PLANNING COMMISSION STAFF REPORT

TAREEF TALALA, OWNER OF VILLAGE PUB APPEALING THE PLANNING DIRECTOR'S DECISION TO DENY A REQUEST TO EXPAND AN OUTDOOR PATIO ONTO THE PUBLIC RIGHT-OF-WAY LOCATED AT 266 SOUTH PALM CANYON DRIVE. ZONE CBD.

13-053 LUP (APPEAL)

Sidewalk Section

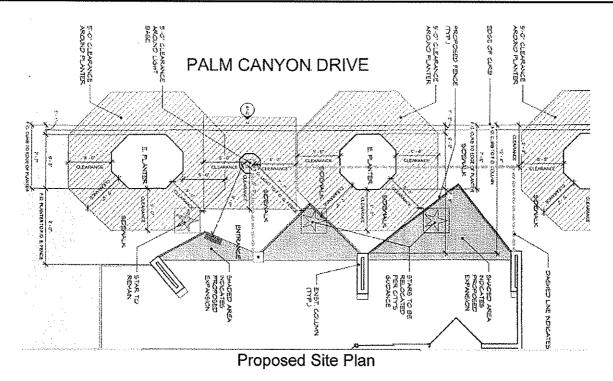
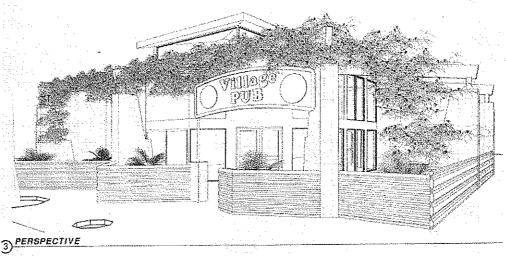
The DUDG provides specific guidelines for sidewalk design providing ample room for concurrent uses. The plan recommends that sidewalks in pedestrian areas have at least (10) feet for window shopping / pedestrian through traffic; ten (10) feet for outdoor dining; three (3) feet for landscaping and shade trees. The sidewalk in front of the Village Pub is fifteen feet wide and does not meet these standards.

Tareef Talala, owner of the Village Pub filed an application to extend the current outdoor patio area eight feet into the public right-of-way narrowing the side walk to five (5) feet. According to the applicant, the new area will allow for additional patio seating. Corrugated metal fencing similar to existing will be utilized as the new patio barrier.

The Planning Director denied the application based upon the determination that the proposed patio expansion does not conform to the Downtown Urban Design Guidelines of the City of Palm Springs General Plan for recommended sidewalk widths of ten (10) feet minimum.

Staff has concluded that the Land Use Permit application (Case 13-053) for a patio expansion will narrow the sidewalk and is not consistent with the Downtown Urban Design Guidelines. The Planning Commission should uphold the Planning Director's decision to deny the application.
